Mt Piper Power Station Ash Placement Project

Submissions Report

March 2011

Mt Piper Power Station Ash Placement Project Environmental Assessment Application Reference: 09_0186

- **Figure 2-2 Calculation of MHRDC multiplier (study point used to find harvestable right multiplier value indicated by arrow)**

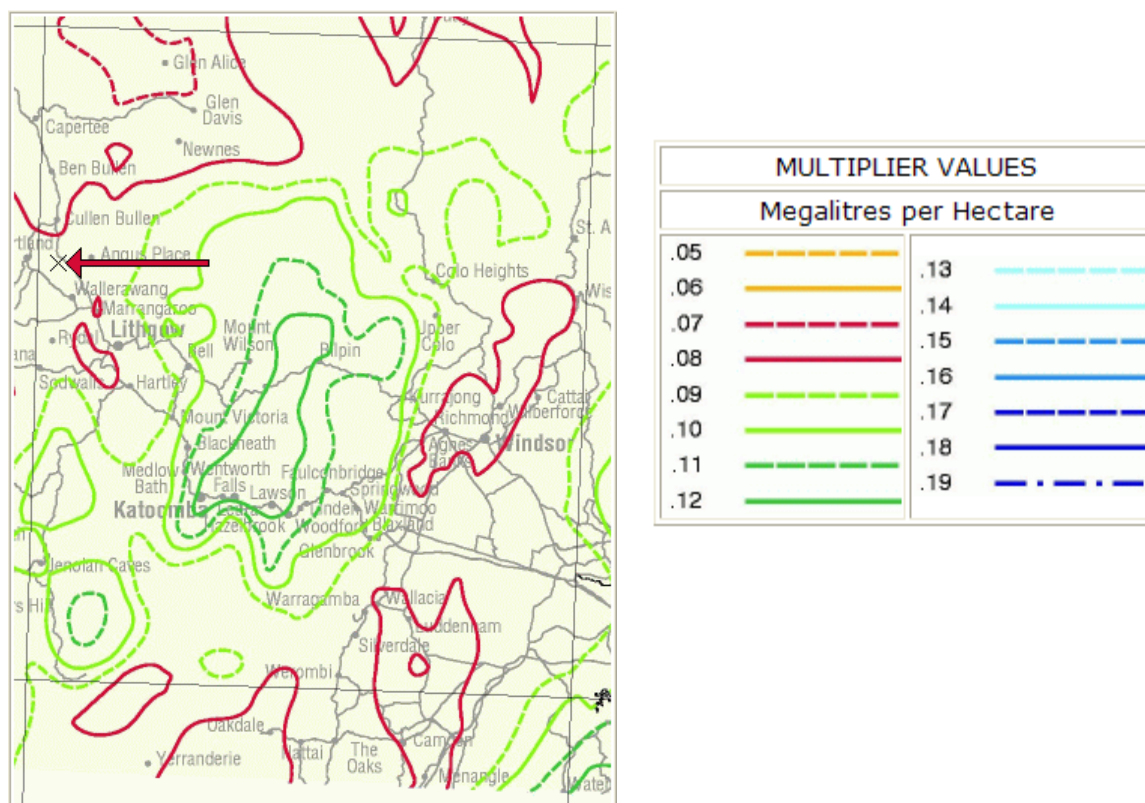
NOW has concerns over the accuracy of the site water balance model and seeks clarification of the site water balance. The site water balance is to be revised prior to project commencement with the balance to take into account:

- The volumes of groundwater seepage into the GCB;
- Provide details on water usage for current ash disposal areas and predicted water usage requirements for years 1 to 5 for the proposed ash disposal areas;
- Updated evaporation calculations including net evaporation from storages; and
- Net runoff generated, stored and used.

Climate data interpretation - The evaporation data presented in Figure 2-2 in Appendix D of the EA are based on evaporation from an open pan (Class A evaporation pan method), which is replenished on a daily basis. For this reason, Figure 2.2 represents evaporation as exceeding rainfall when in reality across the site it does not.

Additionally, although the Figure 2-2 shows the average evaporation exceeds average rainfall in 9 months of the year, the proposed ash placement facility will harvest rainfall runoff from across the catchments of the site, while the evaporation will be lost from water storages on the site. The water harvested from the catchments of the site will exceed the evaporation lost from the water storages at times throughout the year and therefore there will be water available on site to be used for dust

suppression and rehabilitation. Table 2-11 indicates that rainfall data were converted to runoff via conceptual soil storages dependent on land uses on the site, and that monthly average total evaporation was developed using historical data from 1908 to 2010.

Catchment areas for Huons gully and Lamberts Gully are shown in Figure 3-2 of the EA. **Figure 2-2** and **Table 2-5** show the catchment areas together with calculated MHRDC for the site.
